Service Campaign Bulletin

Campaign No. 2007010004, March 2007

SUBJECT: **MODELS 211, 219, 221, 230, X164**
MODEL YEAR 2007
CHECK INTAKE MANIFOLD AND REPLACE IF NECESSARY; INSTALL UPDATED
ENGINE CONTROL MODULE SOFTWARE (M273 ENGINE)

Figure 1

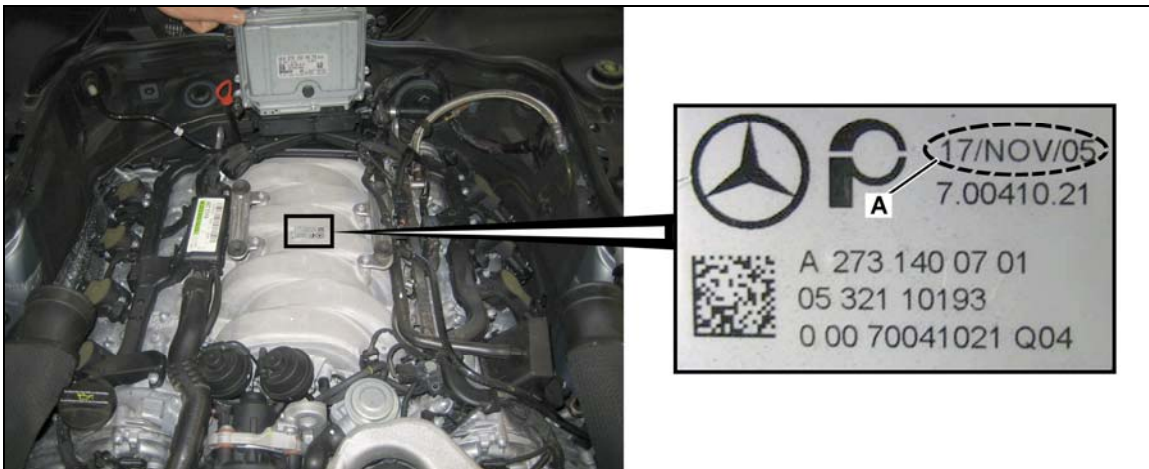
1. Remove both engine air intake ducts.
2. Model X164 only: Remove strut tower brace; refer to WIS document AR62.30-P-2500GY.
3. Remove air filter housing; refer to one of the following WIS documents, depending on vehicle model:
 - Model 211/219: AR09.10-P-1150TS
 - Model 221: AR09.10-P-1150SX
 - Model 230: AR09.10-P-1150RX
 - Model X164: AR09.10-P-1150GZA.
4. Detach engine control module from bracket, keeping electrical connectors connected.
5. Check production date of intake manifold (A, Figure 1).

6. Perform one of the following:
 - Manifold production date up to and including 30/SEPT/05: Proceed to Subject **B** to replace manifold.
 - Manifold production date between (and including) 01/OCT/05 and 28/FEB/06: Proceed to Subject **C** to install engine control module software.

1. Replace intake manifold; refer to one of the following WIS documents, depending on vehicle model:
 - Model 211/219: AR09.20-P-1961TS
 - Model 221: AR09.20-P-1961SX
 - Model 230: AR09.20-P-1961RX
 - Model X164: AR09.20-P-1961GZA.
2. Proceed to Subject **C** to install engine control module software.
